Field Service Bulletin Trucks

SB-10052257-7537

Battery Starter Lug Failure
CXU, GU

FSB 371-045, Battery Cable Lug, Failure

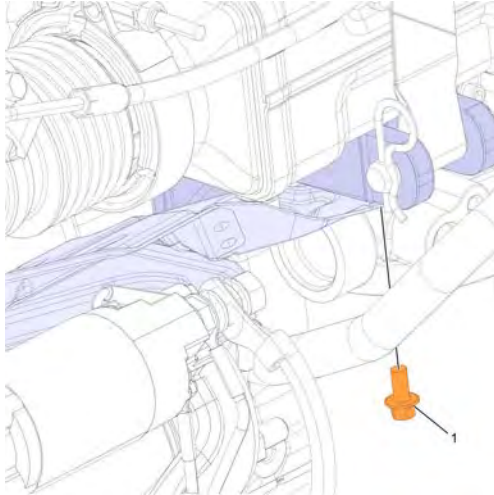
Certain vehicles built from January 1, 2010 to May 28, 2013 with a MP7 engine may experience cracking or breaking of the 90 degree positive battery cable lug at the starter solenoid stud. In some cases, the lug is bent during assembly, and along with engine vibration may cause the terminal to weaken and fail over time.

To support the cable and eliminate this failure, follow the procedure below:

W2080360

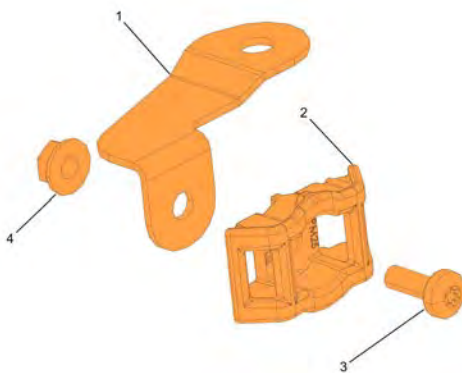
- 1 Secure the vehicle for service by parking it on a flat level surface, applying the parking brake, chocking the rear wheel, and placing the transmission in neutral.
- 2 Disconnect all cables from the negative (ground) battery terminals to prevent personal injury from electrical shock and prevent damage to electrical components.
- 3 Remove the fastener from the heat shield bracket.

W2080361

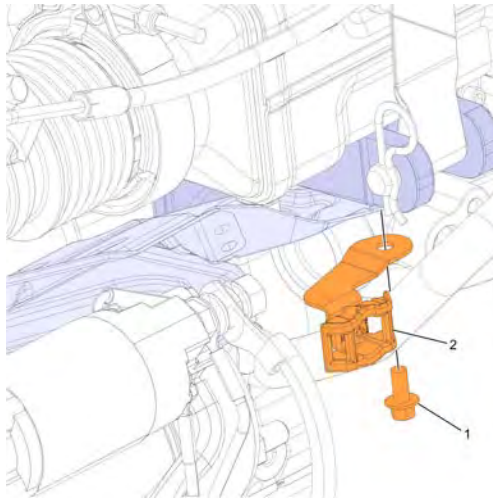
- 4 Preassemble the bracket and the saddle.

W2080362

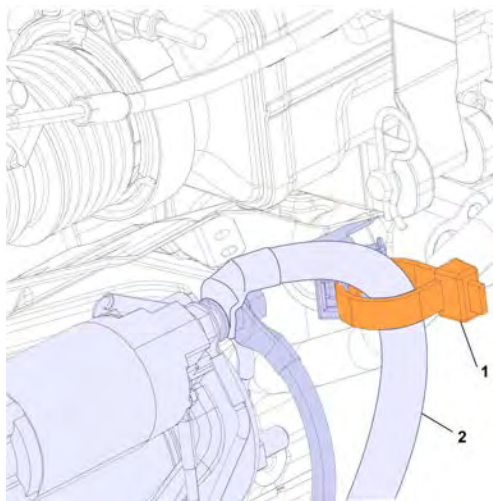
- 5 Install the bracket onto the vehicle and secure.
